PUBLIC HEARING/WORKING SESSION MEMORANDUM

PETITIONS #26-20 & #27-20

355 and 399 Grove Street

To: Neil Cronin, Jennifer Caira – City of Newton
From: Janet Carter Bernardo, P.E. – Horsley Witten Group, Inc.
Date: April 23, 2020, **Follow up June 5, 2020**
Re: Peer Review - Riverside Station: Preliminary Construction Management Plan

Figure 12 - Construction Vehicle/Delivery Routes

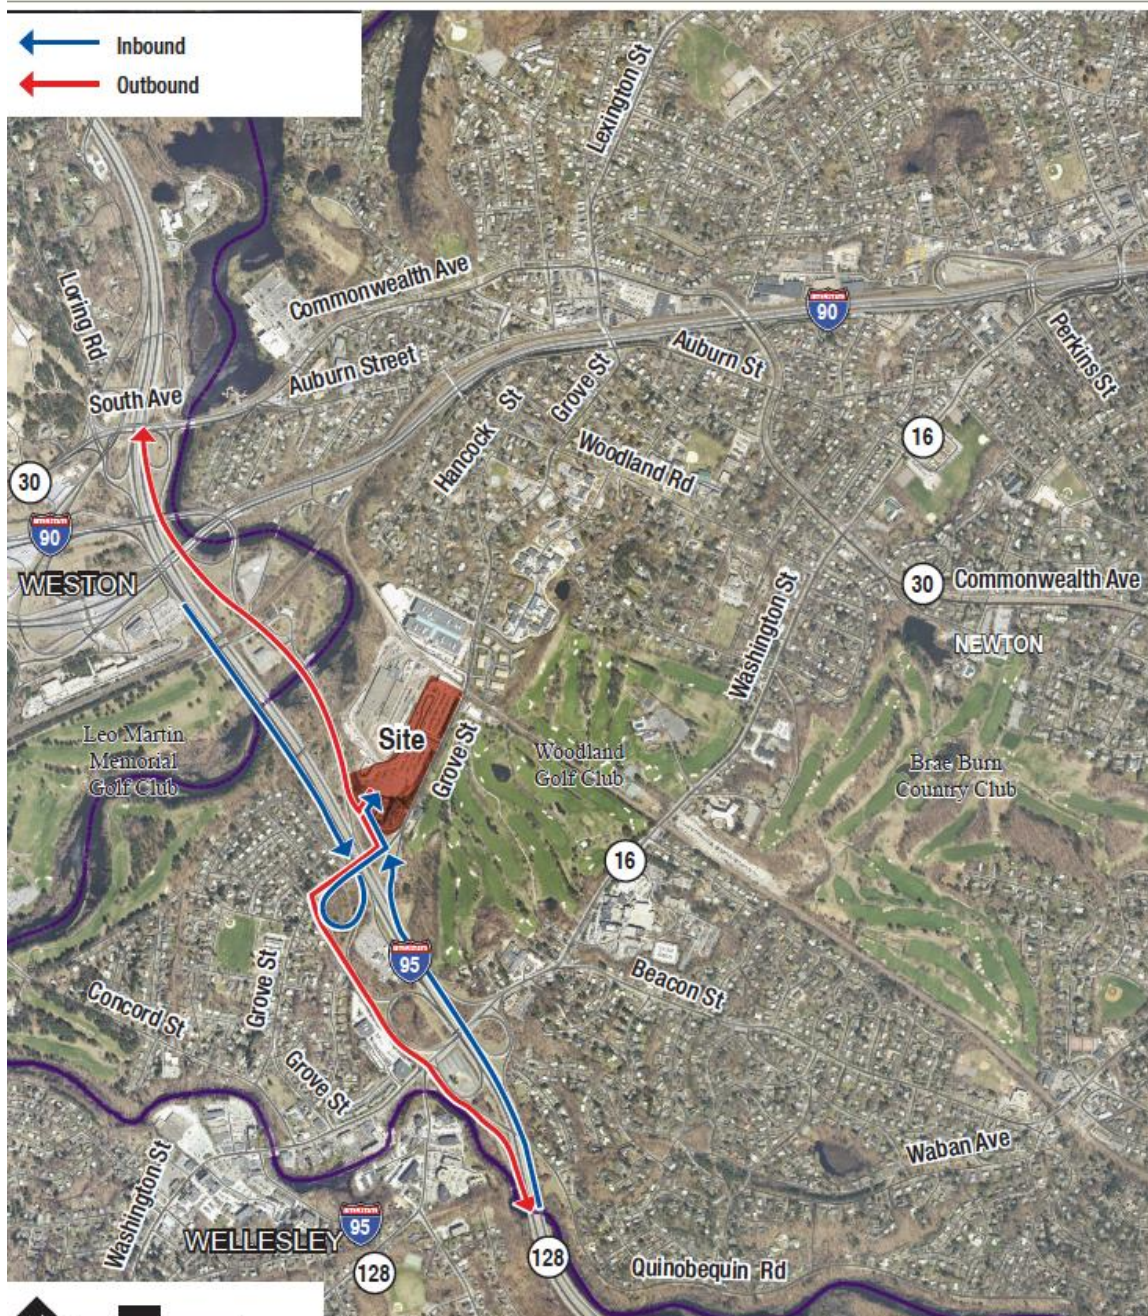
Page 20 of the Updated CMP describes the designated routes for all associated construction truck traffic, truck access to Grove Street has been minimized to the Route 128 corridor interchange. No further comment.
